Access Compliance Report Public Rights-of-Way (Pedestrian Signals)

Main Street: BALL_RD Cross Street: S_BROOKHURST_ST Location: SW

ADA ID: SGAT220202154406 Signal Type: One Push Button-Non APS Overall Compliance: No Severity Scores: BTN 1: 35 BTN 2: N/A No BTN: N/A

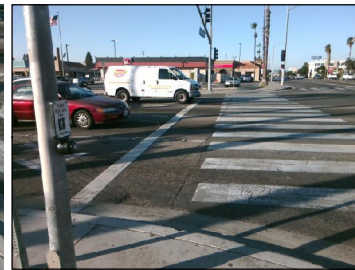
Surveyor Notes: 306 inches from other button (ADA ID: SGAT220202153756)

OC Std/PROW: R404.2, MUTCD 4e.08

Possible Solutions: Replace Signal Push Button With APS Button. Remove and Replace Clear Space.
